SUBJECT: UNIT 1 OFFSITE DOSE CALCULATION MANUAL Revision 9

Enclosed is Revision 9 to the Unit 1 Offsite Dose Calculation Manual (ODCM). This revision accomplishes several tasks, chief among them is the modification of the ODCM to reflect the permanent shutdown of Unit 1. With the permanent shutdown, these following systems are removed from service and were deleted from the ODCM: steam generator blowdown, containment purge, waste gas storage system and various instrumentation associated with the plant vent stack monitoring system. Also incorporated into this revision are the updates of tables used in the gaseous dose calculations that resulted specifically from the 1992 Land Use Census. Further, major changes were made as a result of an evaluation of the Radiological Environmental Monitoring Program. None of the above changes have any impact on the accuracy or reliability of methods for determining dose or setpoint values.

S01-ODCM
Revision 9
08-04-93

Figure 5-3
 Radiological Environmental Monitoring Sample Locations - Orange County

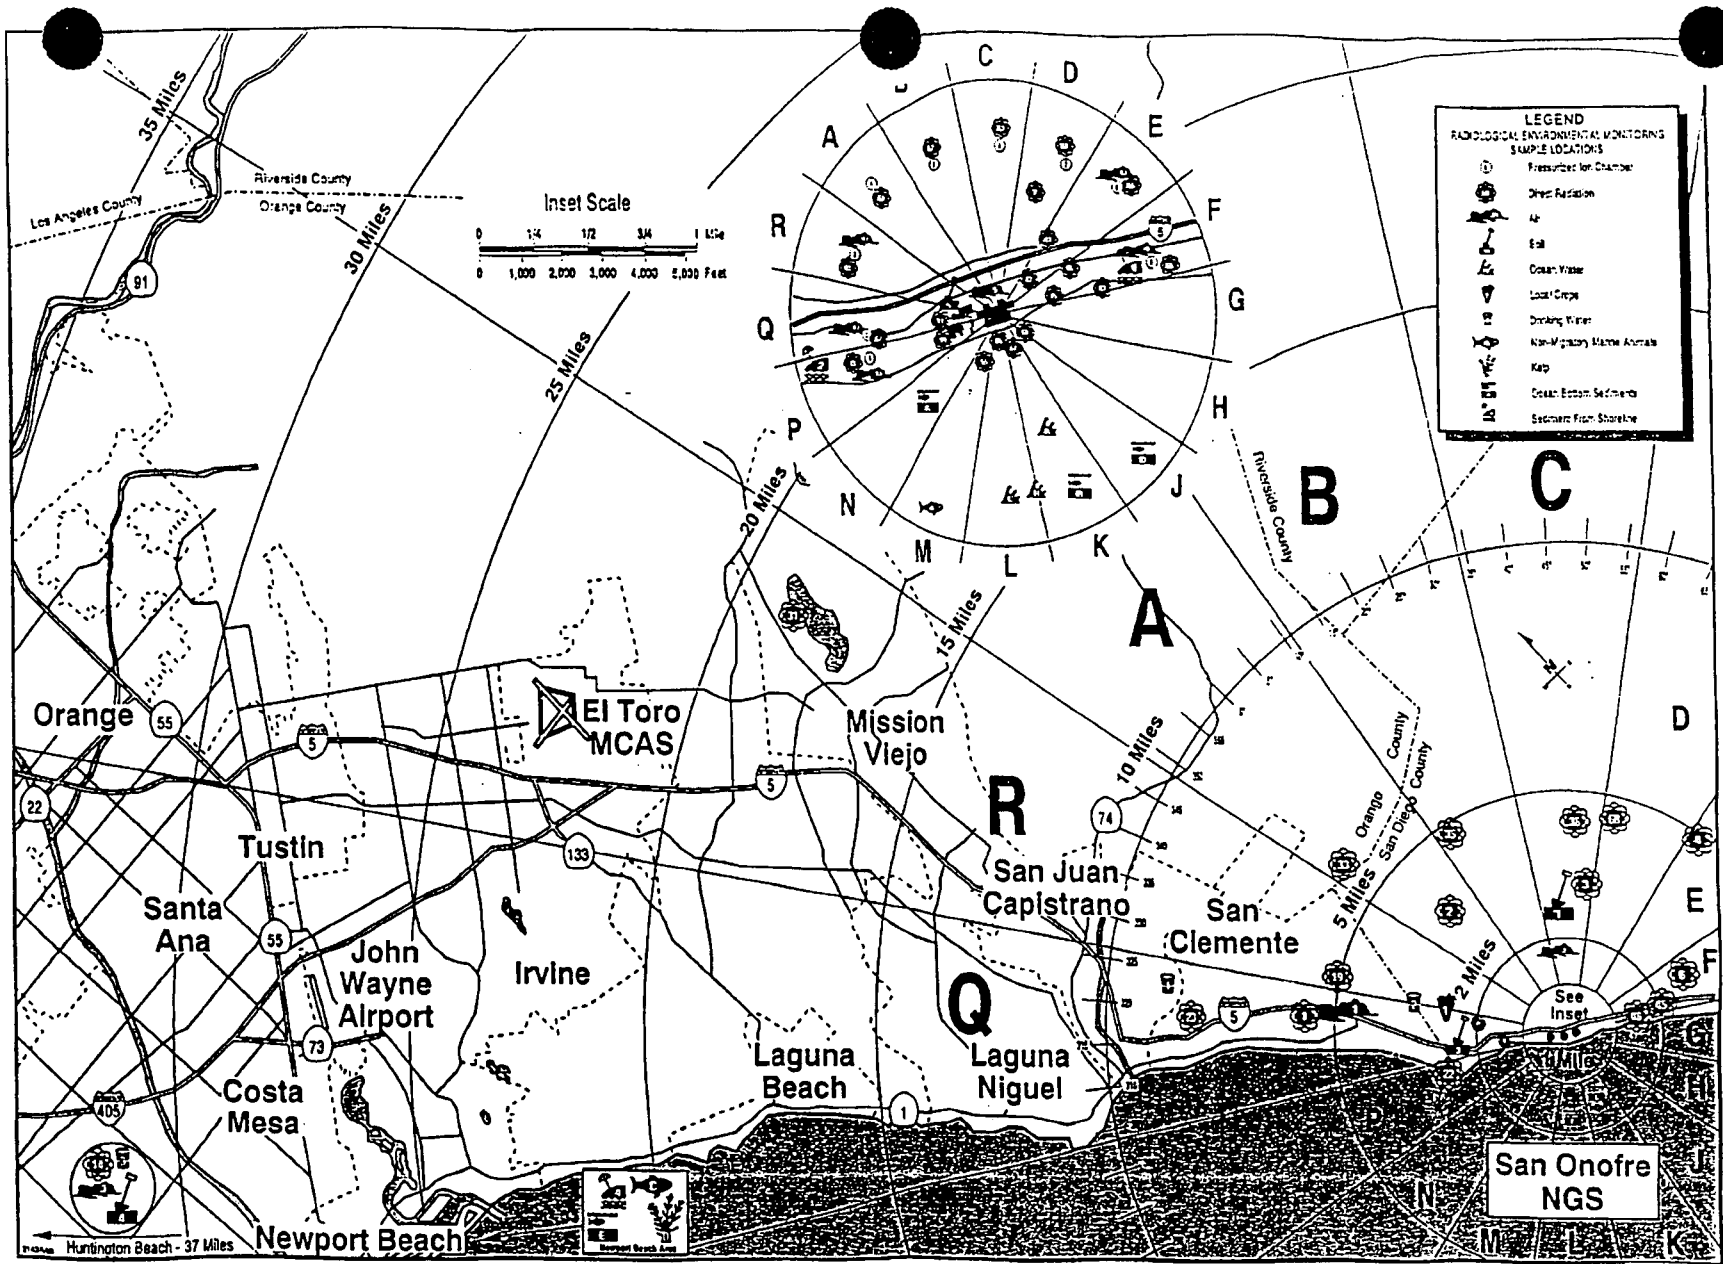
5-28* Revised Figure 5-3.
